Service Bulletin No. 329

MODEL D4505 Coaches	TYPE Field Change Program	SECTION/GROUP 12-Suspension	DATE July 10, 2009
SUBJECT KONI SHOCKS ON FH946 TAG AXLES			
CONDITIONS

Ref. NHTSA Recall No.: 09V-200

Figure 2.

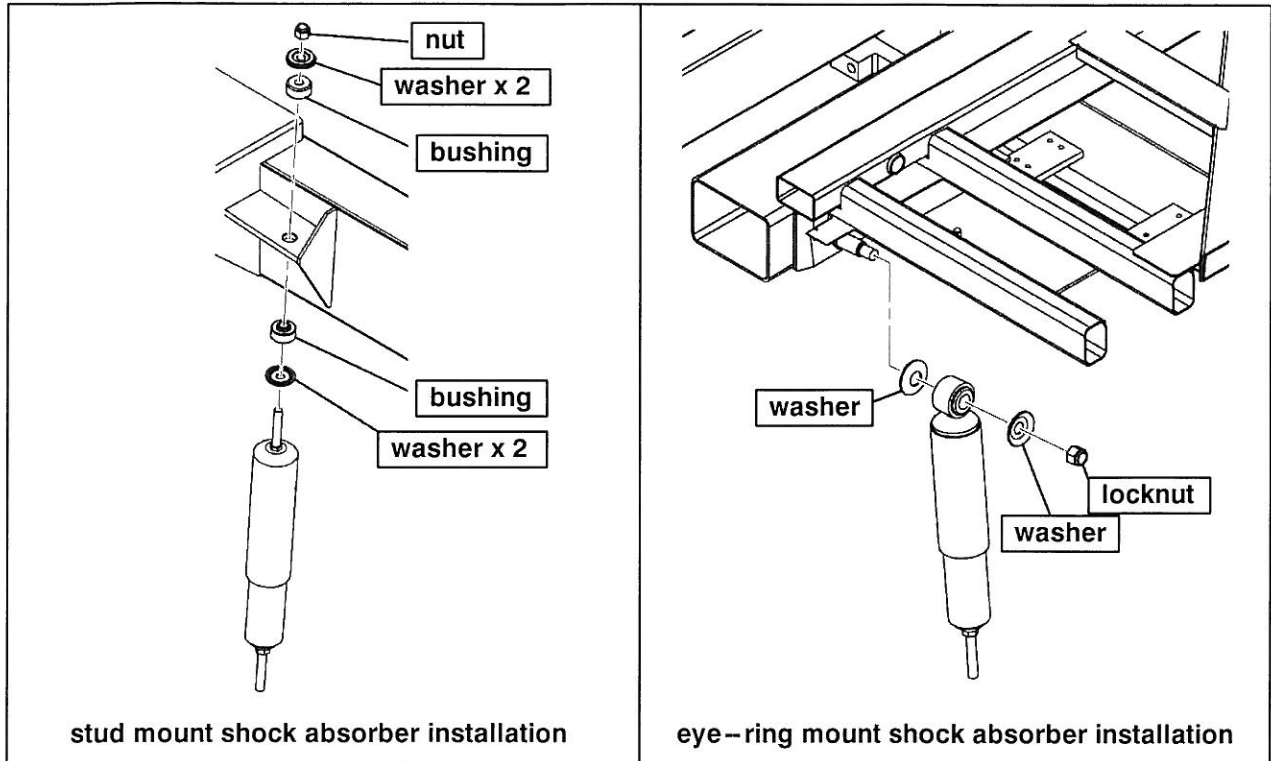
- d. discard the shock absorber, rubber bushings and mounting hardware.
9. To install the eye-ring mount shock absorber (refer to Figures 1 and 2) :
 - a. apply S-23 lubricant to the threads of the lower shock mount,

- b. place inner retaining washers over bushings before installing shocks,
 - c. install upper stud end into its mount and position lower stud end over mounting hole,

- d. apply locktite, p/n 21-7212-18 to locknut. Install outer retaining washer and locknut.
Torque eye-ring mount locknut to 71-79 lbs-ft.
10. Repeat Steps 8. and 9. to remaining eye-ring mount shock absorbers.

Figure 3. Bushing deflection.

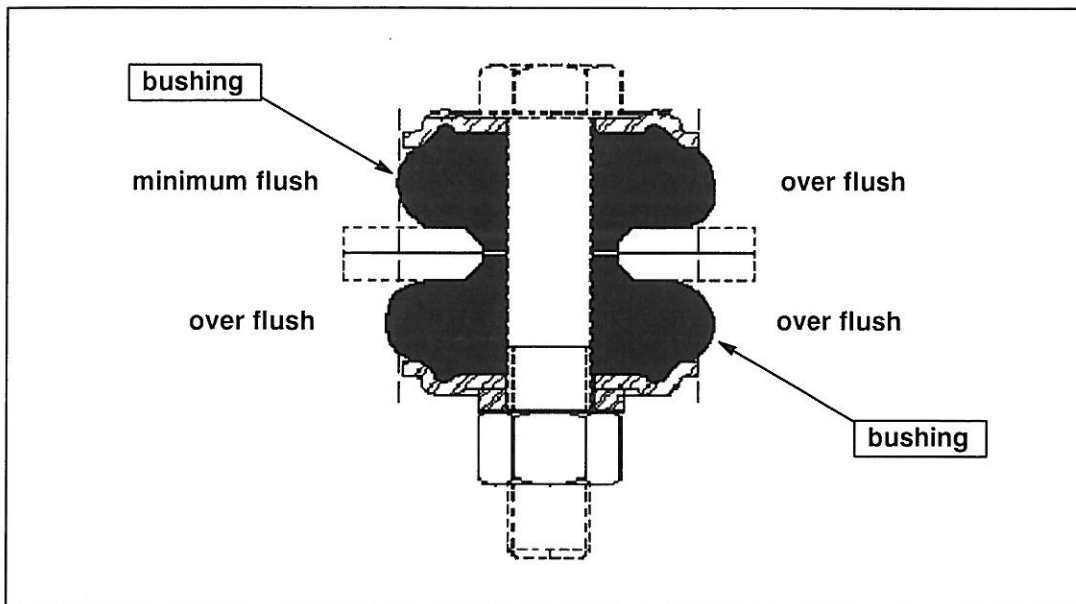
Shock stud connections should be tightened, crushing the rubber bushings so that they are flush with the steel washers. When the shock is not perfectly perpendicular to the mounting plate, the rubber bushings should be flush with the steel washers at one (1) point, and proud (over flush) of the steel washer at all other points (refer to Figure 3).

Figure 4. High rise control solenoid and pressure switch.

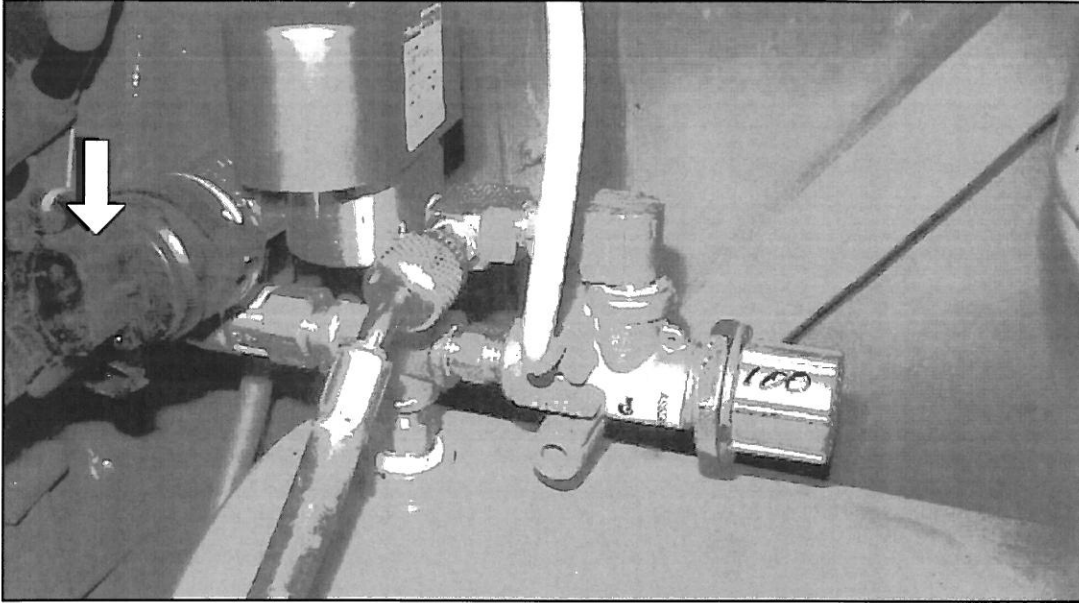
11. Open the curbside, rear side service compartment door. Locate the accessory fill port.
12. Using clean shop air, fill the accessory fill port ensuring that the coach is at full coach pressure on the accessory side.
13. Disconnect the two (2) Packard connectors at the high rise control solenoid and pressure switch (refer to Figure 4).

Figure 5.

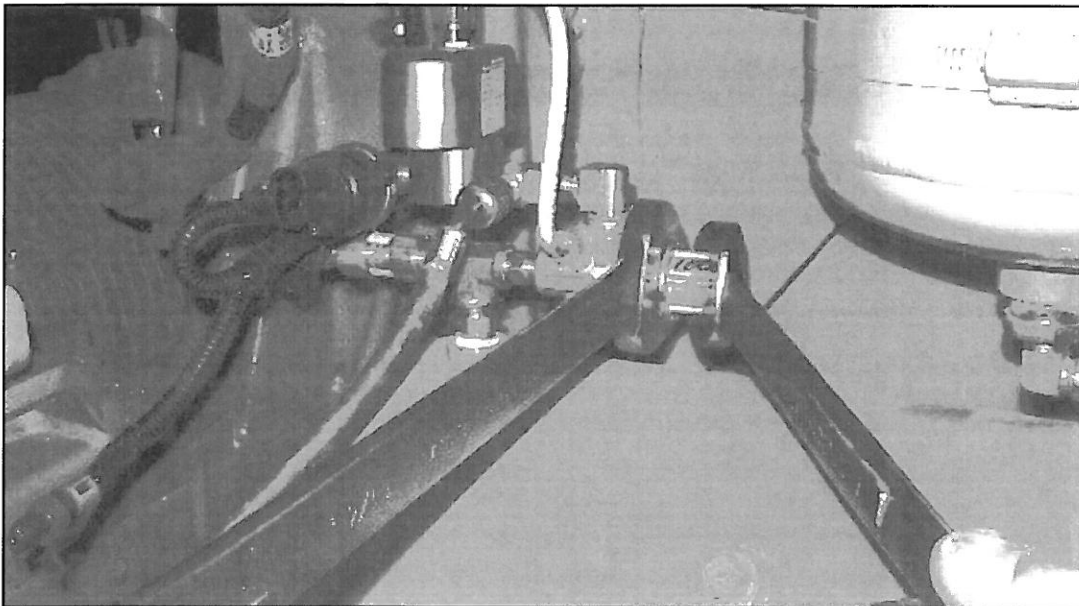
14. Connect an air gauge at regulator test port. Verify that 100 psi is displayed on the air gauge.
15. Using two (2) wrenches, carefully loosen the regulator jam nut, and rotate adjustment knob counter-clockwise until 50 psi is displayed on the connected air gauge (refer to Figure 5).

Figure 6.

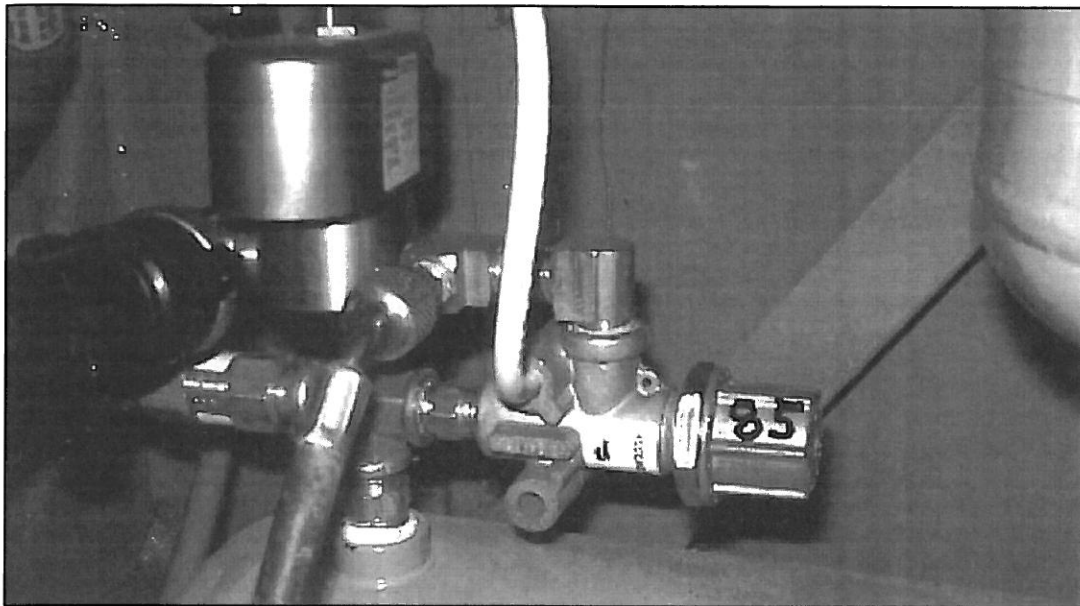
16. Using two (2) wrenches, slowly rotate knob clockwise until the connected air gauge displays 85 psi.
17. Let air pressure stabilize. Verify full coach pressure, and recheck test port at 85 psi.
18. Wipe to remove the 100 psi identification on knob. Mark the new 85 psi setting on knob (refer to Figure 6).

Figure 7.

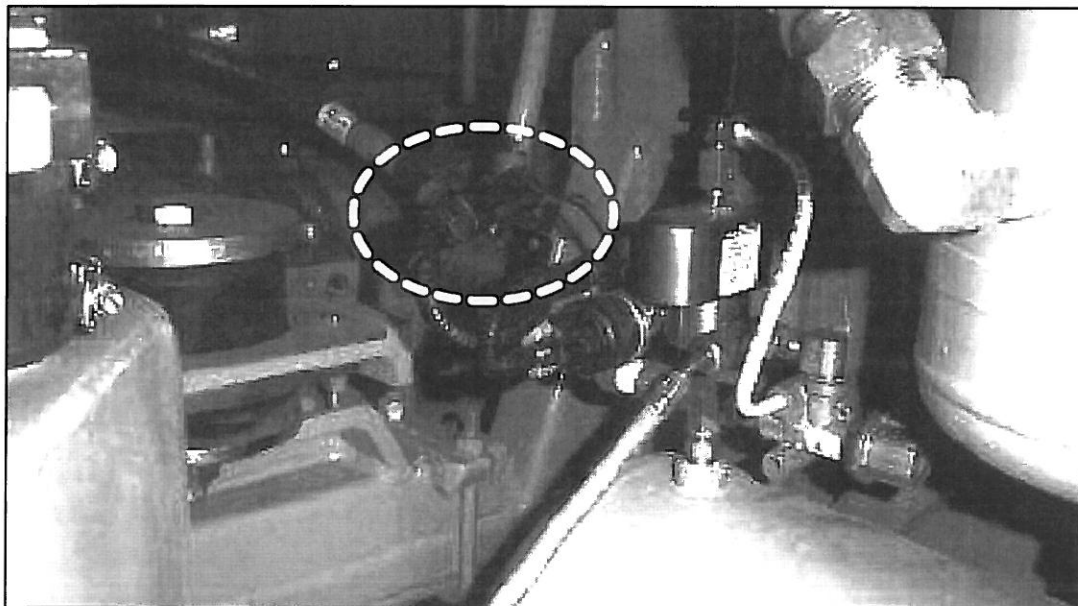
19. Plug in the 2 Packard connectors at the high rise control solenoid and pressure switch.
20. Locate the rear rise solenoid harness (refer to Figure 7). Verify that the rear rise solenoid harness, with red and black cables, is connected. If disconnected, check both harness ends for plugs and discard if plugs are present. Re-connect the two ends of the harness and secure by tyrrapping to sensor.
